Board of Architectural Review (BAR) Certificate of Appropriateness

BAR 17-08-05
419 East Main Street
Tax Parcel 530062000
Holly Ridge, LLC, Owner/ Clifford H. Fox, Applicant
Window Replacement

**CITY OF CHARLOTTESVILLE
BOARD OF ARCHITECTURAL REVIEW
STAFF REPORT
September 19, 2017**

Window Replacement

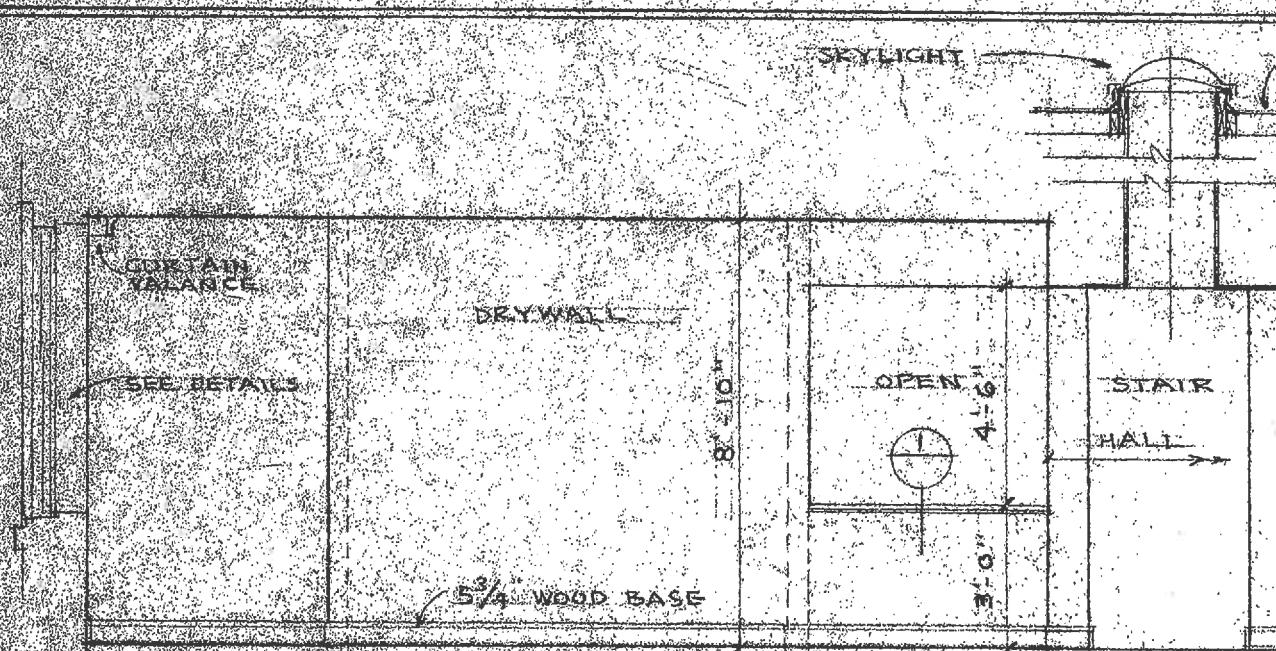
The BAR requested more information:

- 1. How old are the windows? The windows were installed in 1980 or 1981; see architect's stamp and date when the renovation took place.**
- 2. What exactly is broken? The balances for the lower sashes are worn out in the southwest window. Replacement balances are not available for these windows. Neither upper sash will close completely. We have had to screw the upper sashes in place to keep them from sagging. See photo attached.**
- 3. Comparing muntin dimensions between the old windows and the proposed replacements. The existing muntin width is 11/16"; the proposed is 7/8" see the attached profile. I have hand delivered a piece of the exterior muntin profile of the requested.**

WEST WALL ELEVATION AT LIVING ROOM 2-02

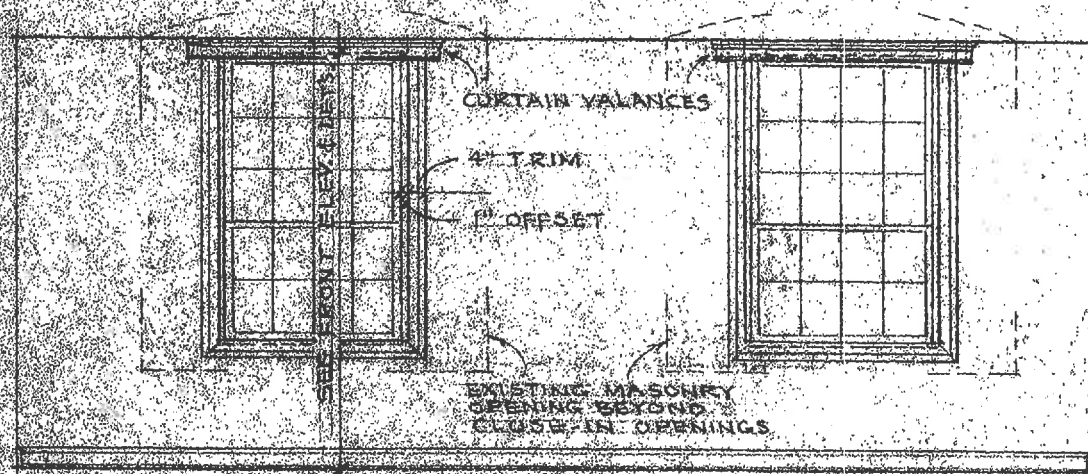
Carl Schwartz and staff met with the applicant to view the existing windows. New information submitted by the applicant includes drawings prepared when the windows were installed, dated 1980 or 1981. Therefore, due to the recent age of the windows, it is appropriate to replace them. The proposed aluminum clad windows are appropriate although the muntin width (7/8") is wider than the existing (11/16").
